New Jersey Transit: A/C Hose Installation

Property and Top Bus Number: 416 Standard Floor New Jersey Transit Buses

Issue: This work instruction provides information for the installation a newer type A/C hose on older buses in the fleet.

New hose
installed

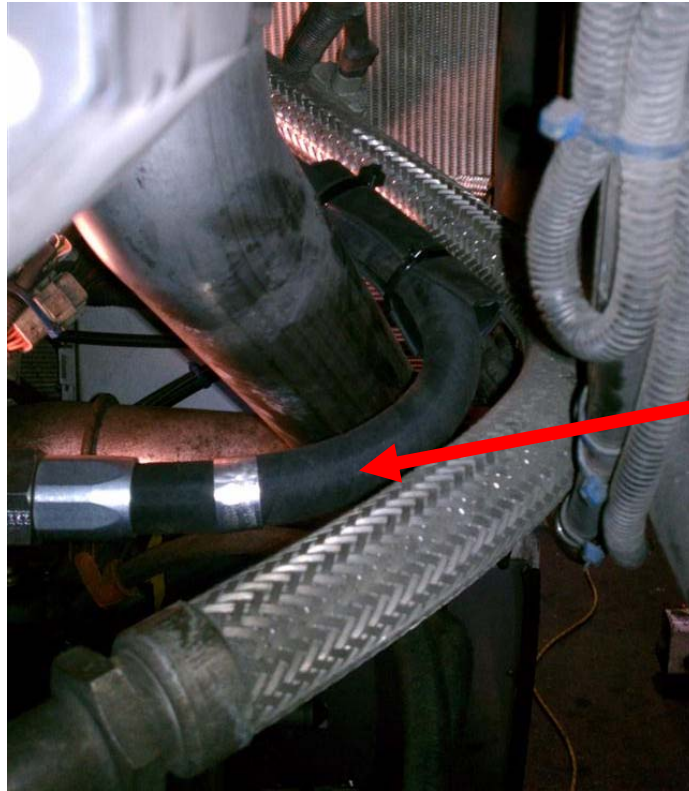
5. The pictures below show the routing of the old and new hoses.
6. When installing the new hose it needs 2 clamps added like what is on the newer buses for better support.

Clamps that need
to be installed with
the new hose

1. This instruction is to show the routing of the new a/c hose on the older buses.
2. Turn battery disconnect switch off when working in the engine compartment.
3. Follow the recommendation of the NABI Maintenance Manual about discharging and re-charging the AC system.
4. The part number of the new longer hose is **10B-7447-001**.
